APPLICATION NO.	FILING DATE	FIRST NAMED INVENTOR	ATTORNEY DOCKET NO.	CONFIRMATION NO.
10/524,273	08/11/2005	Javier Marti Sendra	027318-00007	1001

Office Action Summary	Application No. 10/524,273	Applicant(s) MARTI SENDRA ET AL.	
	Examiner Omar Rojas	Art Unit 2874

DETAILED ACTION

In re claim 1, Kosaka discloses a system of coupling between a dielectric optical guide 13 and a planar photonic crystal guide 12, characterised by the fact that it consists of a coupling structure 11 necessary for adapting the width between both guides. Figure 2 of Kosaka is reproduced below.

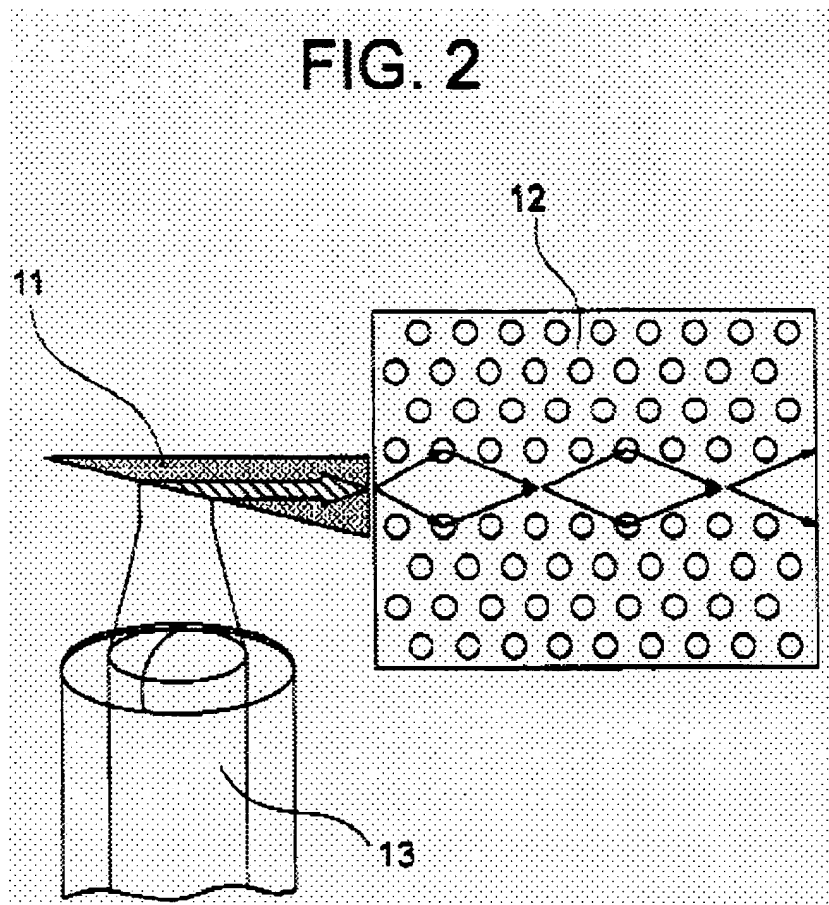
In re claim 2, the coupling structure 11 of Kosaka inherently has a length, width and shape, as seen in Figure 2, depending on the characteristics of both the dielectric guide 13 and the photonic crystal guide 12.

In re claim 3, the photonic crystal guide 12 of Kosaka inherently has a grid constant, radius and height of the cylinders and contrast of indices between the material of the columns, the material surrounding the columns and the material above and below the crystal as suggested by Figure 2.

Figure 17(a) of Dridi is reproduced below.

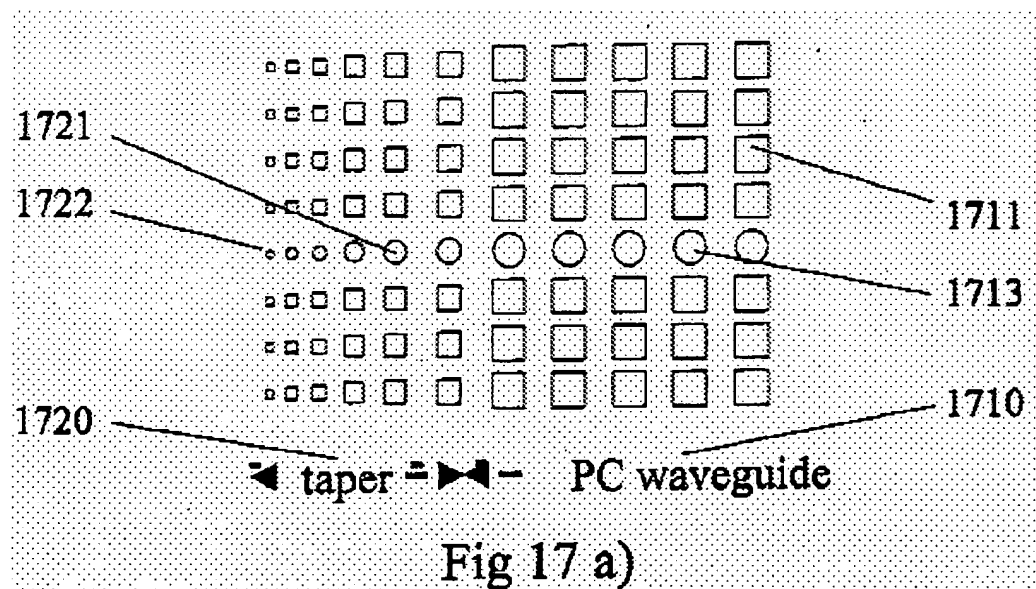
Dridi, on the hand, discloses introducing point defects 1721,1722 into a coupling structure (Figure 17) by selecting a particular number of defects and one or more defect characteristics including radius, dielectric constant, relative position and height. *See* Dridi at paragraph [0146].

In re claim 6, an optimum number of defects 1721, 1722 is inherently chosen in Dridi as well as the characteristics of each one of them, both for introducing the light from a dielectric guide into a photonic crystal guide as for extracting the light from a photonic crystal guide into a dielectric guide because Dridi teaches low loss adiabatic transfer of energy between waveguides. *See* Dridi at paragraph [0047]. Therefore, it would have been obvious to one of ordinary skill in the art at the time of the claimed invention to obtain the invention specified by claim 6 in view of Kosaka combined with Dridi for the same reasons given with respect to claims 1-5.
